Architectural Review Committee Staff Report Meeting Date: October 17, 2023

PETITIONER: Culver's

PETITION: Culver's Architectural Design

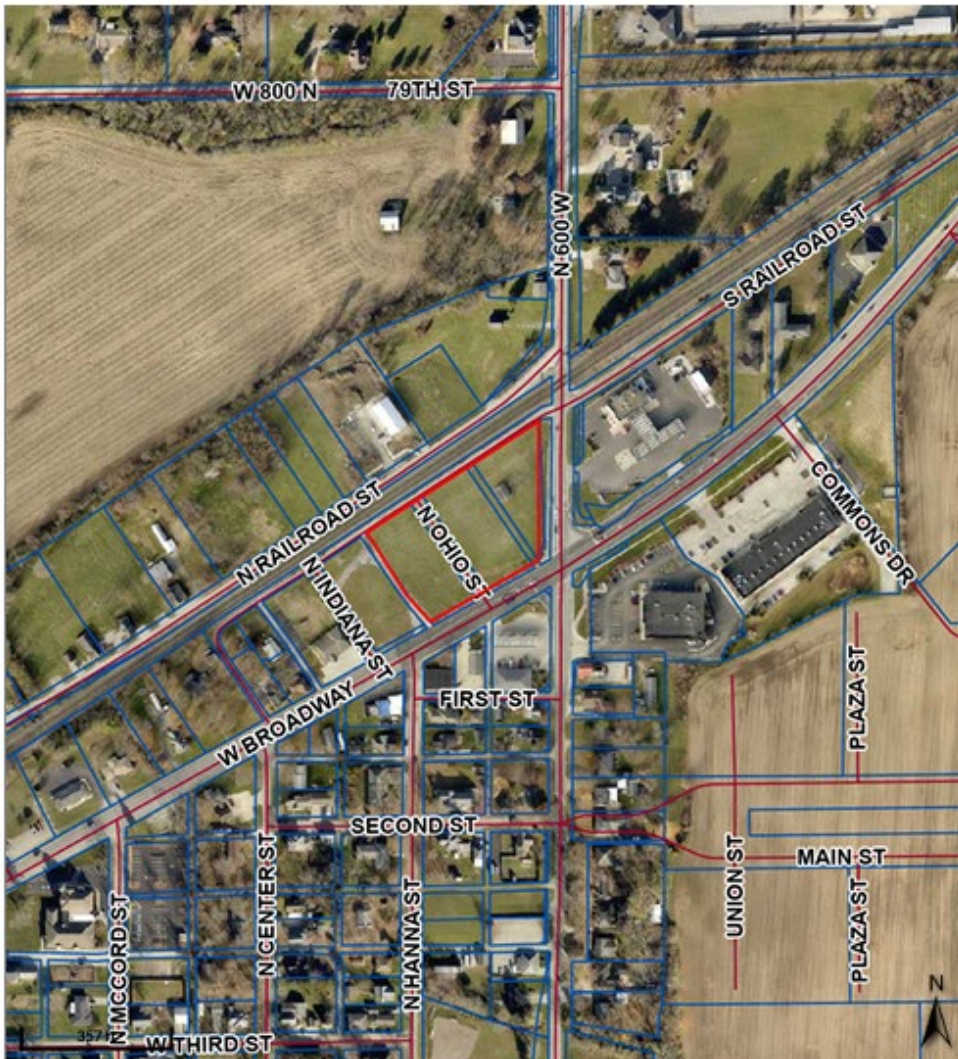
Staff finds the petitioner's plans generally in compliance with the BZA's conditions of approval, but we would like gain input from the ARC on the 4th item. Staff feels a portion of the storage area lacks a "top" similar to the rest of the building. We would suggest a dimensional cornice band.

Staff is in support of the wall plane articulation alternative as proposed. We would like to see discussion on the design of the storage area but are generally in support of the overall design of the building.

1. The west façade shall feature a minimum of an awning or canopy over the service door, and a minimum of 2 windows (or faux windows).
2. The window awnings shall be similar to what is shown in the pictures provided by the petitioner.
3. The cornice shall be a neutral color complimentary to the other exterior colors of the building.
4. There is a cooler/storage noted on the site plan, this shall be fully integrated into the building design and shall feature the same materials and level of architectural design as the rest of the building.
